FINAL
YEAR 4 (2017) ANNUAL MONITORING REPORT
MARTIN'S CREEK II MITIGATION PROJECT

Cherokee County, North Carolina
DMS Project No. 92633 (Contract No. 005717)
USACE Action ID No. SAW – 2009-00209/DWR Project No. 10-0952
SCO No. 08-07251-01

RE: Martin's Creek II Monitoring (DMS Project # 92633, Contract # 005717)
Final MY4 (2017) Annual Monitoring Report

Axiom Environmental, Inc. (AXE) is pleased to provide you with three hard copies and a CD of digital files for the Final Martin's Creek II Annual Monitoring Report. We received your comments via email on November 28, 2017 and have addressed them as follows:

Site	Martins Creek II
Project Number:	92633
XS ID	XS - 3, Riffle
Reach	UT 1- 3, Reach 2
Date:	5/18/2017
Field Crew:	Perkinson, Jernigan

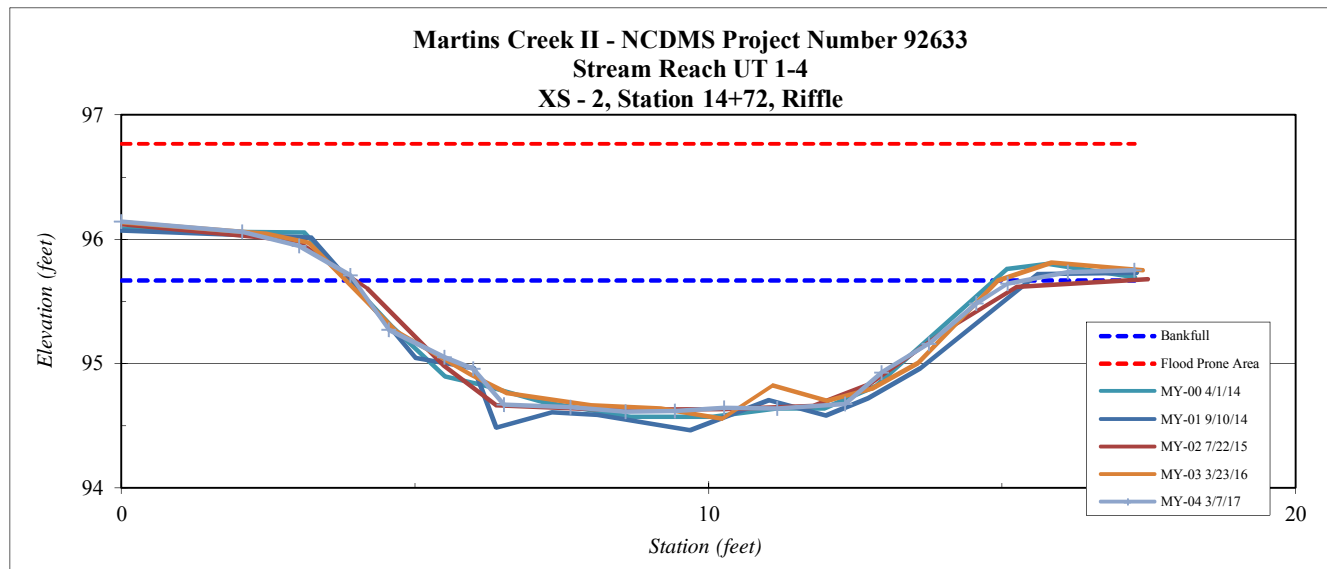
Cross Sections and Table 11: The IRT has requested that Bank Height Ratios be calculated. Please calculate BHR for x-sections and update Table 11.

The bank height ratio was recalculated for all cross-sections, and since only 2 cross-sections exhibited any streambed elevation change, only 2 bank height ratios changed. Cross-section 3 has a bank height ratio of 1.16 and cross-section 13 has a bank height ratio of 1.71. All other cross-sections have a bank height ratio of 1.0, indicating minimal geomorphic change and good cross-sectional stability.

Martins Creek II Groundwater Gauge 2 Year 4 (2017 Data)

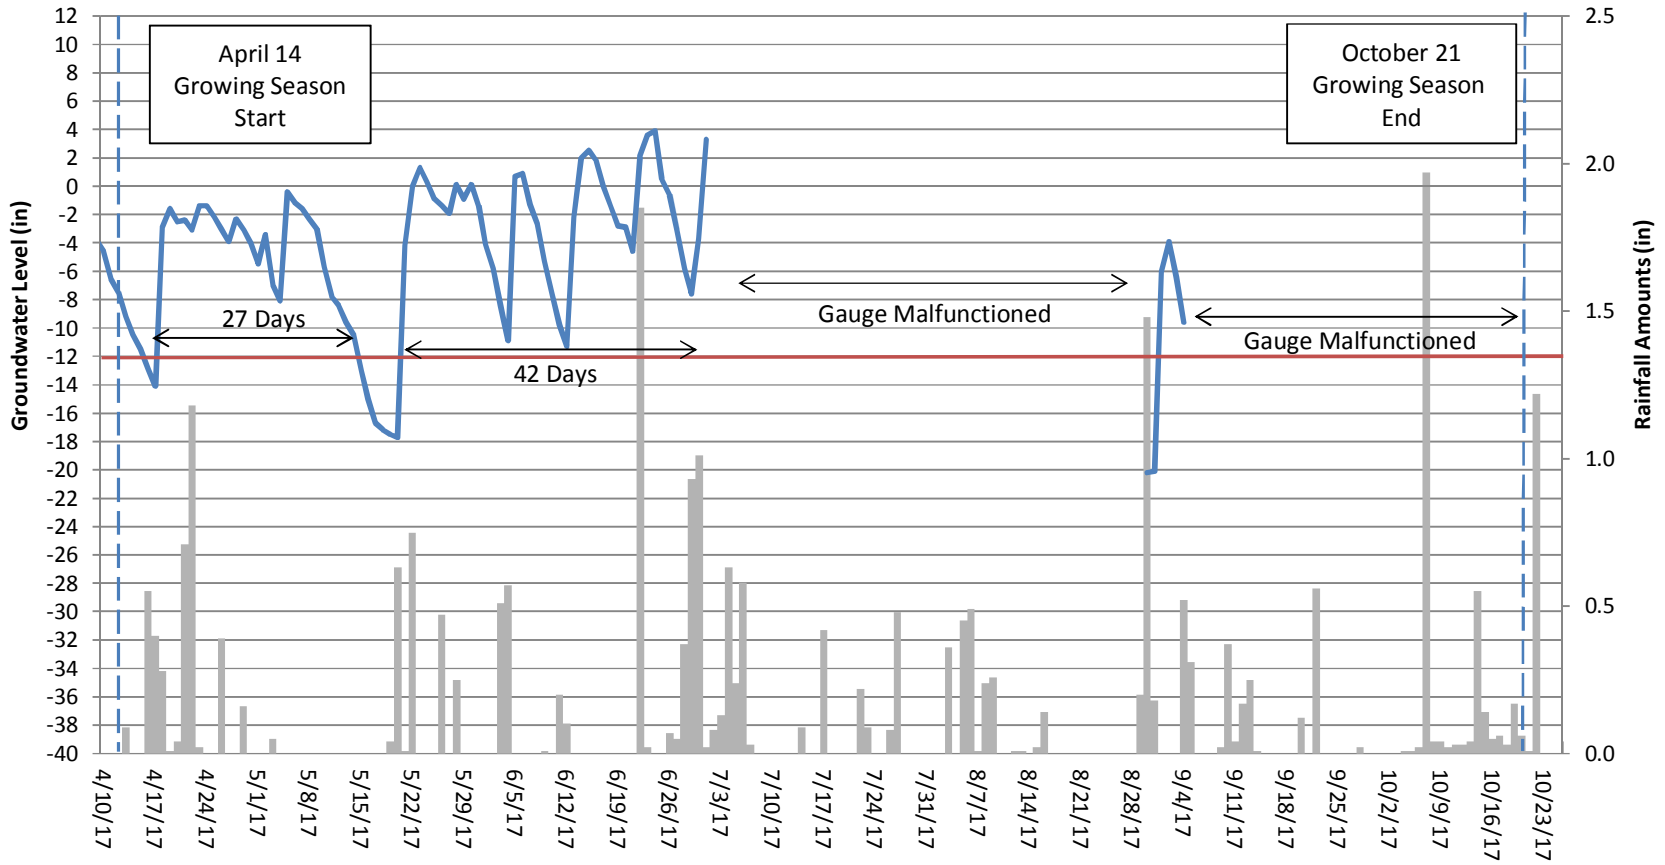
2.3 Wetland Hydrology: Gauges 2 and 11 have documented malfunctions occurring in MY4 and did not record the complete monitoring period. Have these gauges been repaired and/or replaced? If not, please let DMS know so replacement gauges can be provided if needed. Please add short discussion in section 2.3 Wetland Hydrology regarding the two malfunctioning gauges and the repair/replacement solution.

The following was added to the wetland hydrology discussion: "Gauge 2 malfunctioned on July 1, 2017 and was replaced on August 30, 2017. The new gauge collected data for just 6 days before malfunctioning again for the remainder of the growing season; however, it was saturated/inundated for 42 days prior to its malfunction. Gauge 11 malfunctioned on August 29, 2017 resulting in loss of data for the remainder of the growing season. The gauge had not met success criteria prior to its malfunction, and it is not expected to have met success criteria during the period of its malfunction. Both gauges were replaced with functioning gauges, and, as of November 8, 2017, were functioning properly." Axiom keeps several DMS-owned gauges in stock and brings them to every site visit in anticipation of gauge malfunction. We will request additional replacement gauges from DMS if the need arises.

Martin's Creek II
Sample Time-Lapse Photos from MC UT1R2 (Downstream Camera)

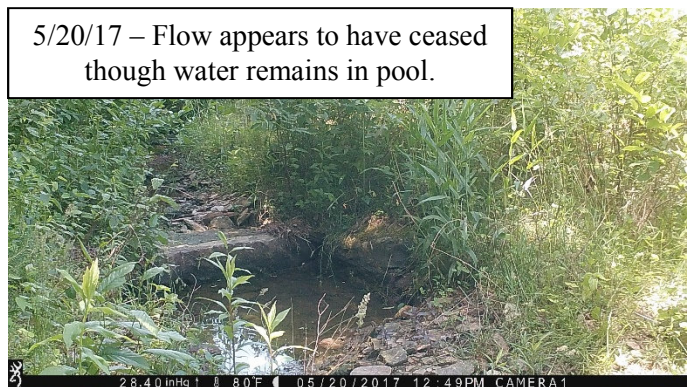
Please also add a page at the end of the report showing some pictures collected with dates.

A sampling of photos from each camera was added to the hydrology data in Appendix E.
